**NATIONAL INSTITUTE OF  
OCCUPATIONAL SAFETY AND HEALTH**

**ADVISORY BOARD ON RADIATION AND WORKER HEALTH**

***REVIEW OF NIOSH/ORAUT PROCEDURES AND METHODS  
USED FOR DOSE RECONSTRUCTION  
(Supplement 1)***

**Contract No. 200-2004-03805  
SCA-TR-TASK3-0001, Revision 1**

**Figure 3.7-1. K-S and A-D Statistics for All Distributions Fitted to a Sample of 10,000 Products using Crystal Ball 2000 Batch Fit Procedure**

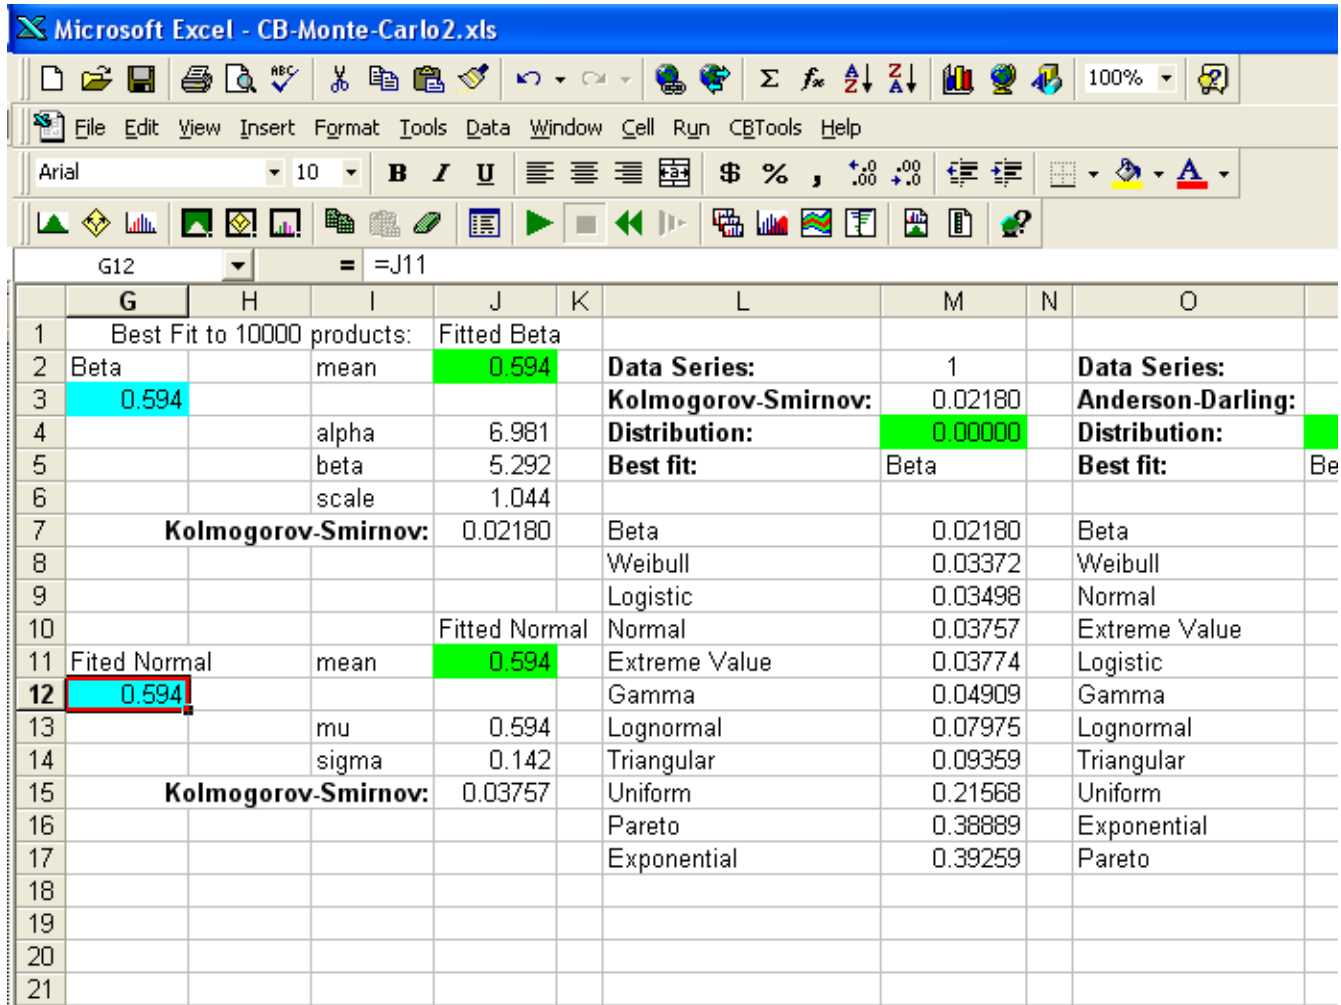
The results, shown in Figure 1, indicate that the beta distribution was found to be the best-fitting distribution under both criteria. In both cases, the second-best fit was obtained using a Weibull distribution. The normal distribution ranks third when using the A-D criterion, and fourth when using the K-S criterion.

**Figure 3.7-4. Comparison of Statistics Obtained from Samples of Size 10,000 from the Best-Fitting Beta Distribution and the Best-Fitting Normal Distribution**

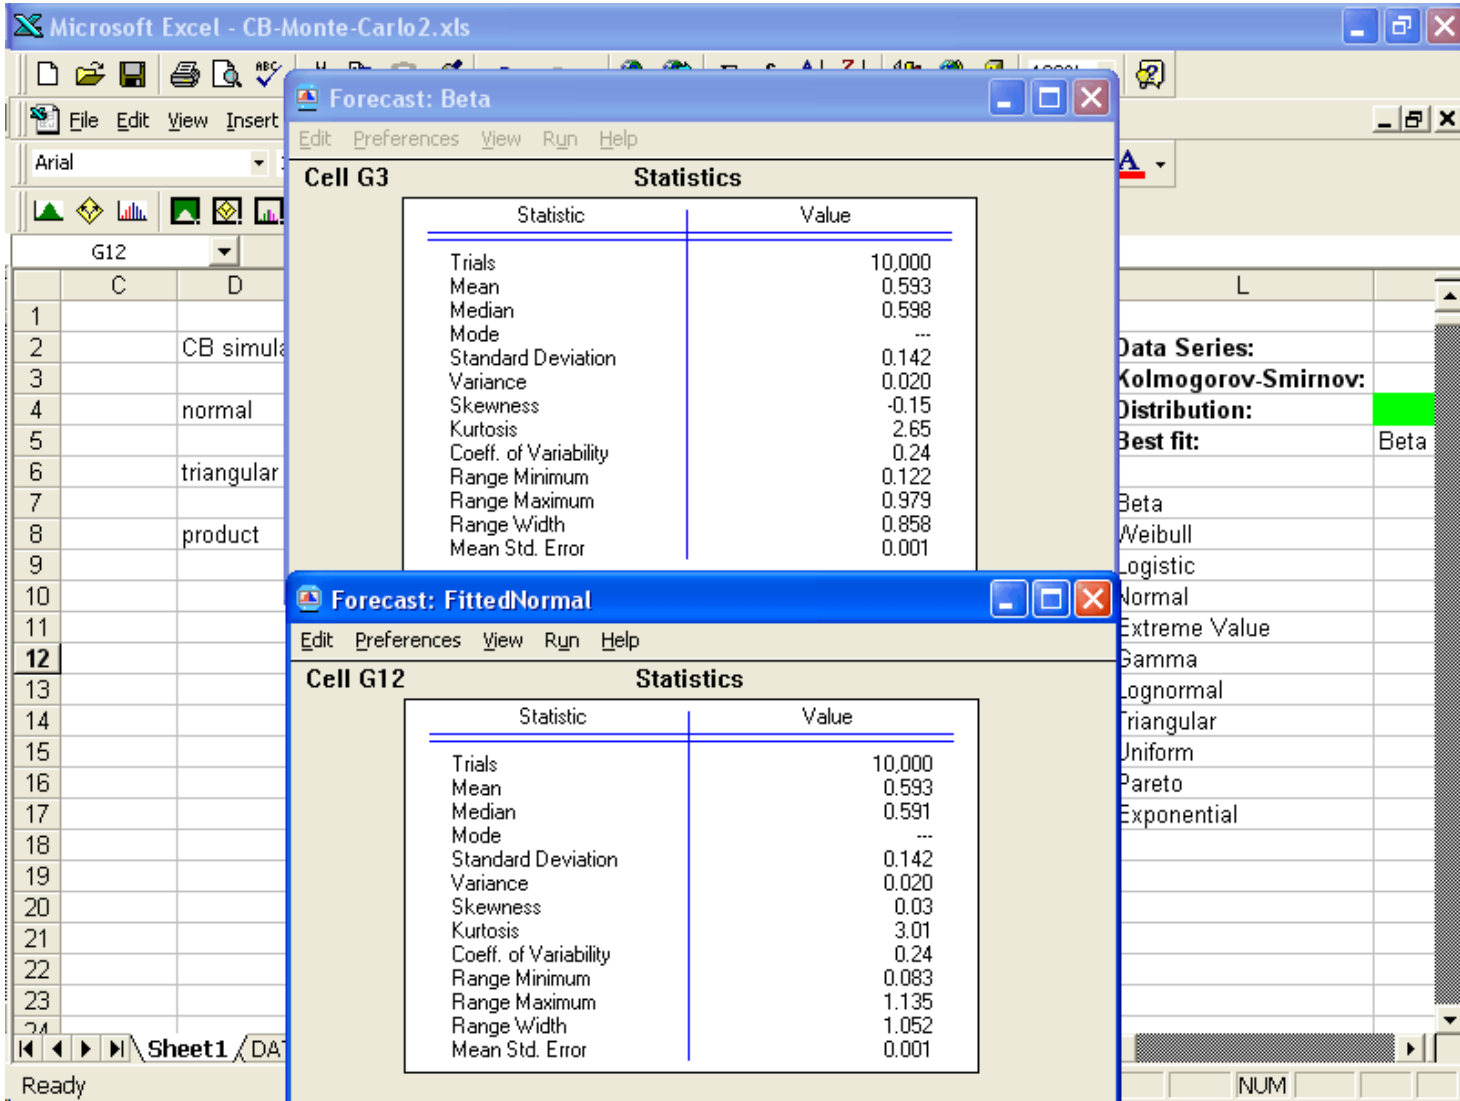
Two samples of size 10,000 were simulated in Crystal Ball 2000 using the fitted beta and normal distribution with parameters stated above. Despite the clearly better fit of the beta distribution based on the statistical tests, there is little difference in the statistics obtained from the two simulated data sets, as shown in Figure 4. This confirms that the best-fitting normal distribution provides a good approximation for the distribution of the product organ doses in the example selected. If the normal distributions for the dosimeter reading have a larger standard deviation than the 0.10 value in this example, it is likely that a normal distribution will continue to provide a good approximation to the distribution of the product's organ doses.

**Figure 3.10-1. Comparison of Lapel to Fixed Station Air Sampling**  
(Source: Caldwell et al. 1967)

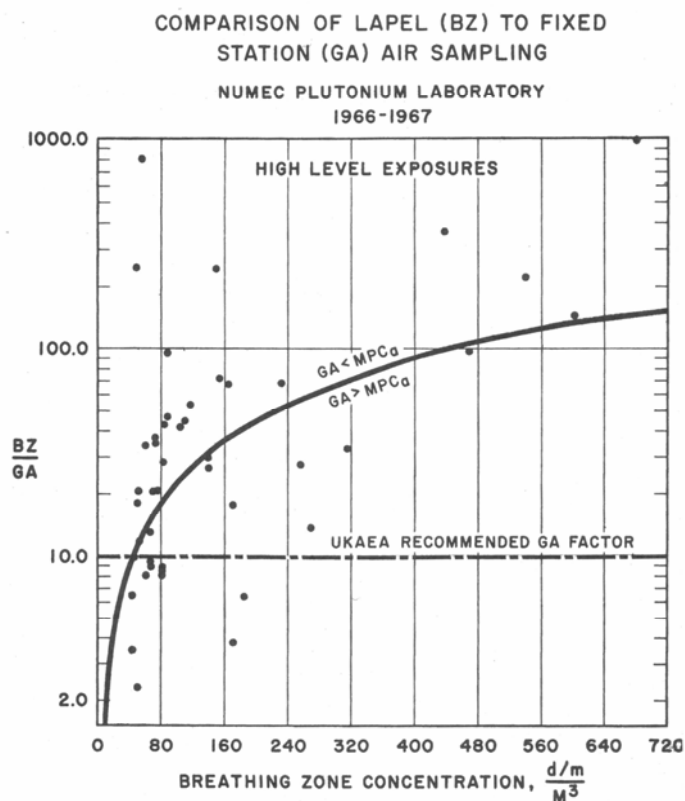
samples. Figure 3.10-1 below illustrates the strong tendency of GA samples to underestimate the air concentrations to which a worker is exposed. Important to note is that this discrepancy increases with air concentrations, and at the MPC level is, on average, about 70-fold too low.

Based on these data, a “rigorous” air monitoring program would require a comprehensive **breathing zone** air sampling program for individual workers and facility processes that is best defined by periodic low-volume **lapel** air sampling that extends over the total (or a large fraction) of an 8-hour workday. When BZ air sampling is not performed or not adequately performed in the workplace and general area air sampling is used as the basis of the air monitoring program, established monitoring guidelines may not have been adequately met.
